Re: Wagoner Building
1800 Randolph Rd. SE
Traffic Circulation Layout
Engineer's 03-23-23 (M15-D008)

Based upon the information provided in your submittal received 03-27-23, the above referenced plan cannot be approved for Building Permit until the following comments are addressed:

CIVIL SITE & TRAFFIC CONTROL PLAN

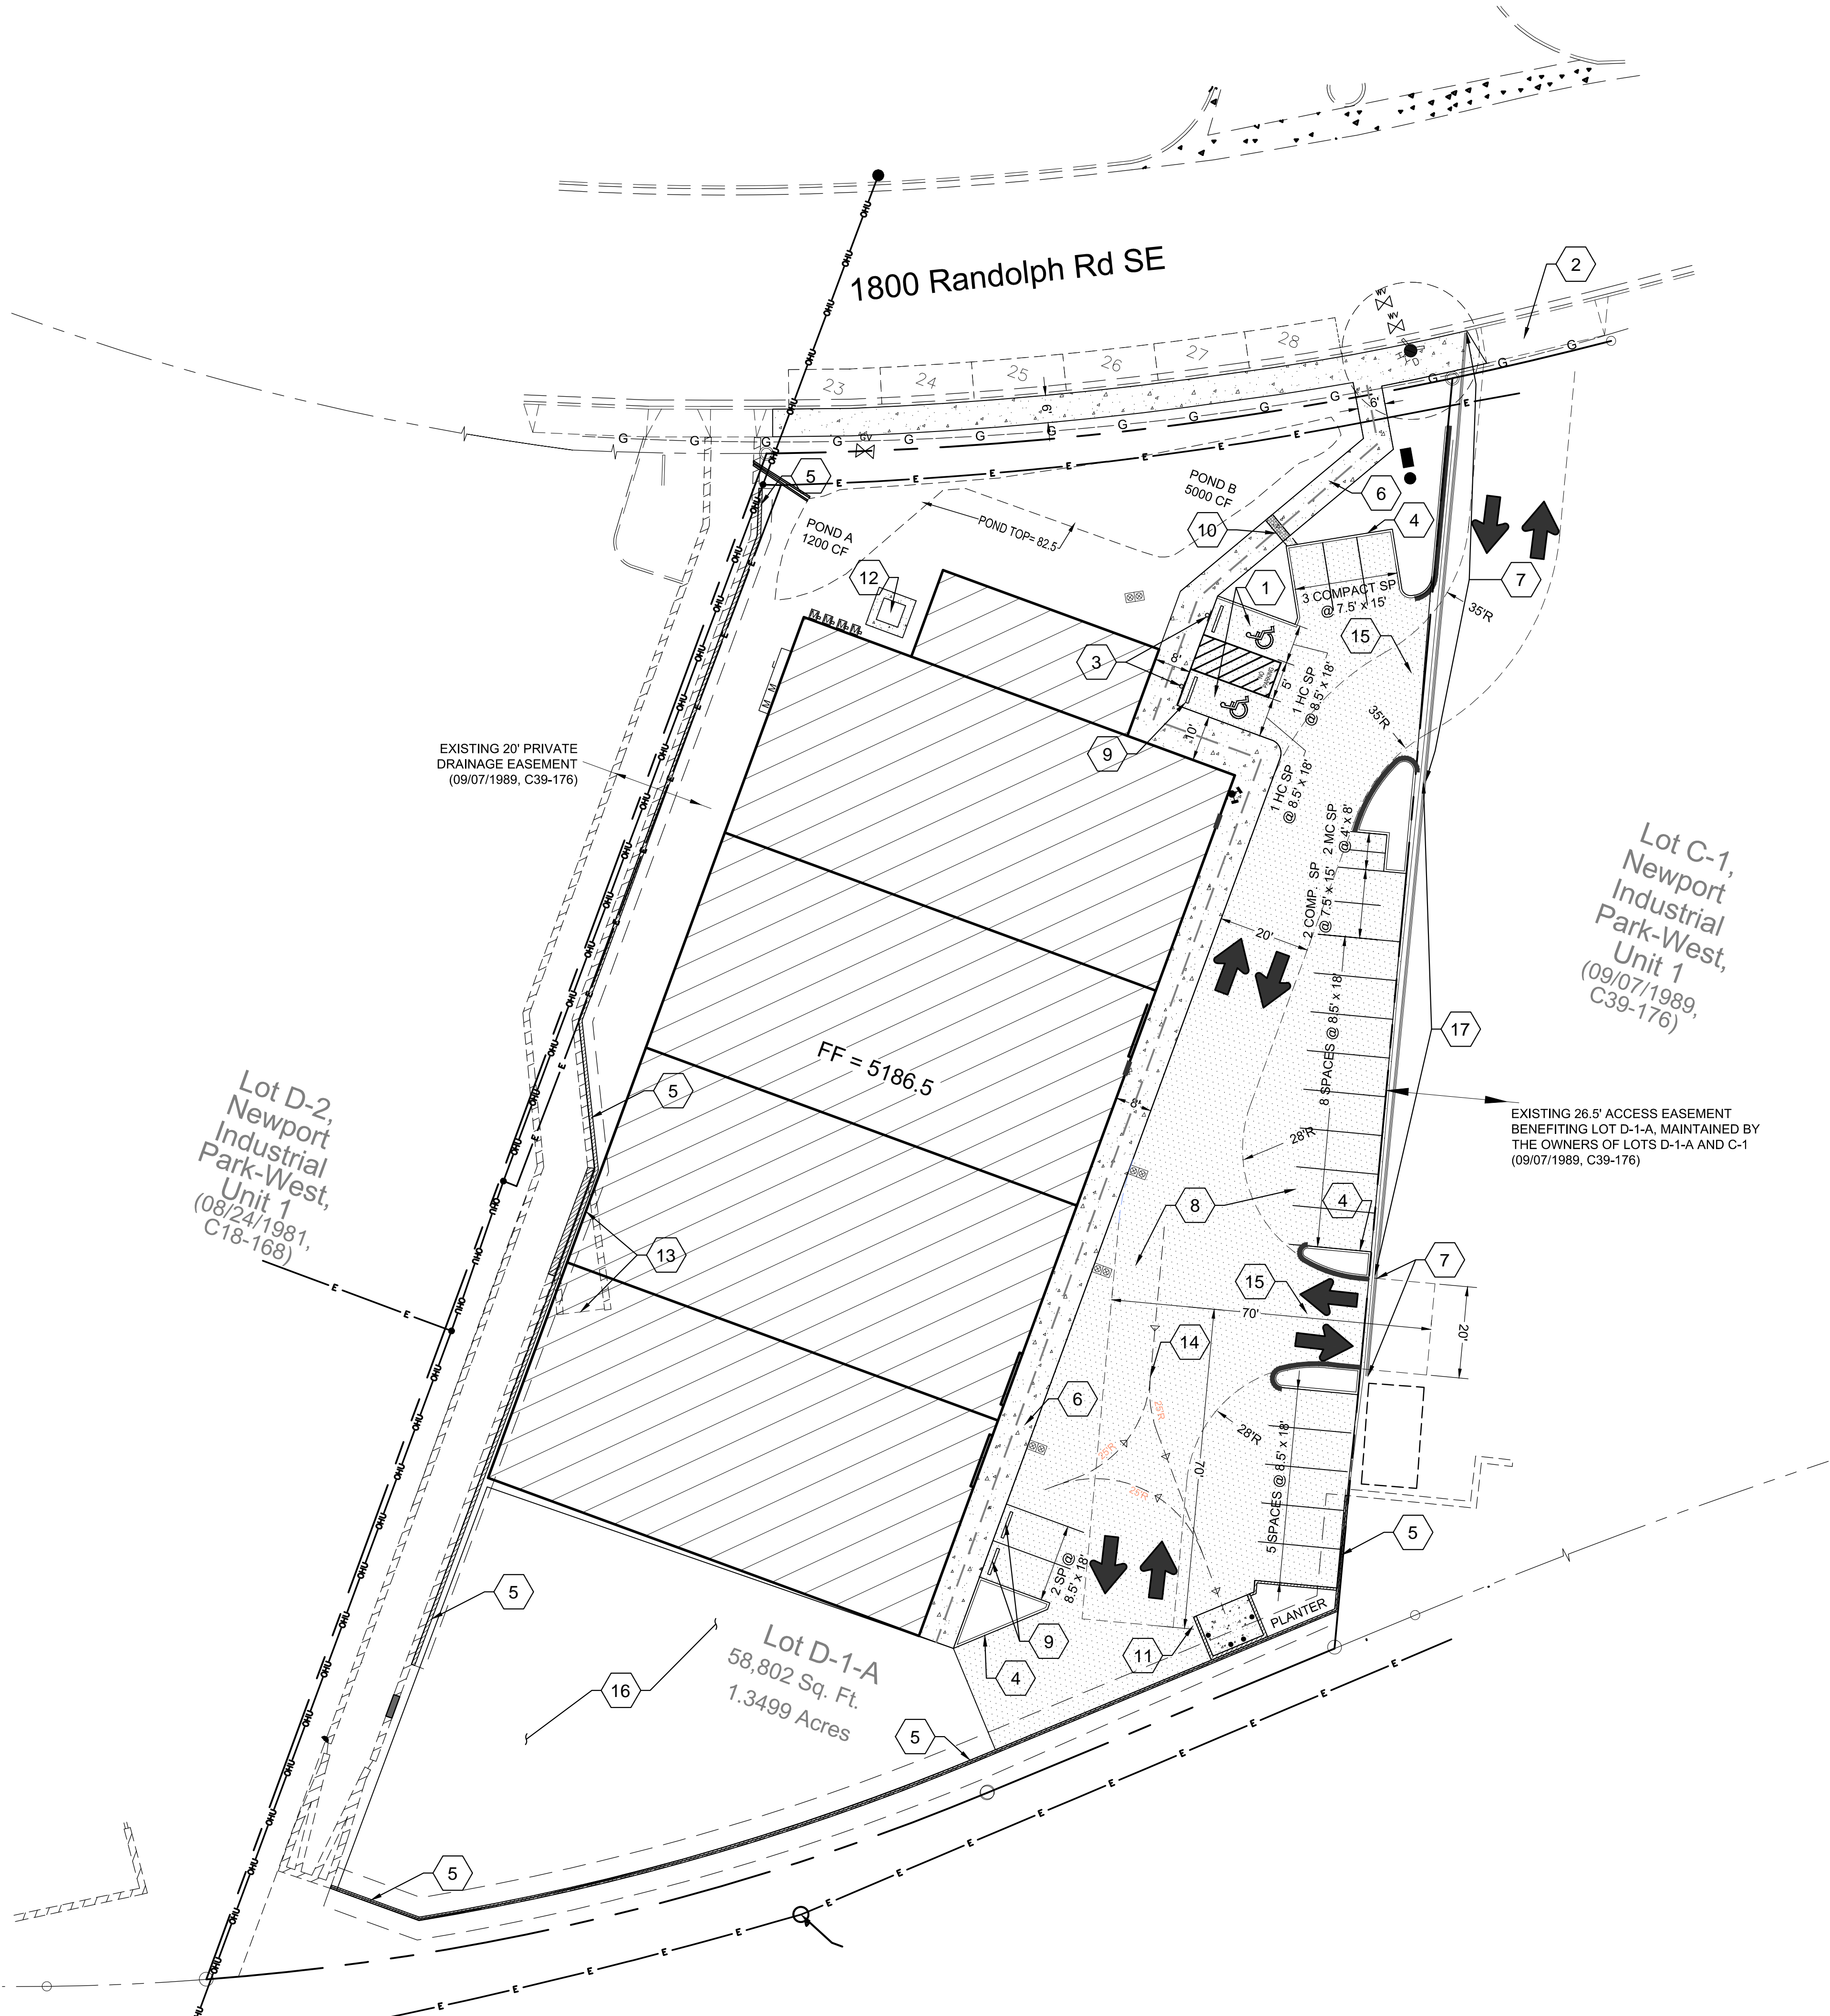
1. Identify all existing access easements and rights of way width dimensions.
2. Identify the right of way width, medians, curb cuts, and street widths on Randolph Rd. SE.
3. Please define the property line.
4. Please provide approved plat showing the access easement.
5. Please provide shared access agreement with the adjacent property.
6. Please provide details for the proposed sidewalk, and reference COA std dwg 2430.
7. On street parking is generally prohibited on Arterial street. Please note that Randolph is classified as Minor Arterial.
8. Minimum two-way Drive Aisle Width and two ways access's width should be minimum 22 ft.

9. Label the compact parking spaces by placing the words "**COMPACT**" on the pavement of each space.
10. The ADA accessible spaces must include an access aisle. Van accessible aisles should be 8ft wide; all others should be 5ft wide.

11. The pavement marking "MC" should be shown in the opposite direction for motorcycles entering the parking space.
12. All bicycle racks shall be designed according to the following guidelines:

13. Bicycle racks shall be sturdy and anchored to a concrete pad.
14. A 1-foot clear zone around the bicycle parking stall shall be provided.
15. Bicycle parking spaces shall be at least 6 feet long and 2 feet wide.

16. List radii for all curves shown; for passenger vehicles. Radius for delivery trucks, fire trucks, etc. is 25 ft. or larger.
17. All sidewalks along streets should be placed at the property line.

18. Curbing should be installed to delineate landscape, parking, and pedestrian ways and identify points of access. Please call out detail and location of barrier curb.

19. Refuse vehicle maneuvering shall be contained on-site. The refuse vehicle shall not back into the public right of way.; provide a copy of refuse approval.

20. Provide a copy of Fire Marshal approval.
21. Show the clear sight triangle and add the following note to the plan: "Landscaping and signage will not interfere with clear sight requirements. Therefore, signs, walls, trees, and shrubbery between 3 and 8 feet tall (as measured from the gutter pan) will not be acceptable in the clear sight triangle.
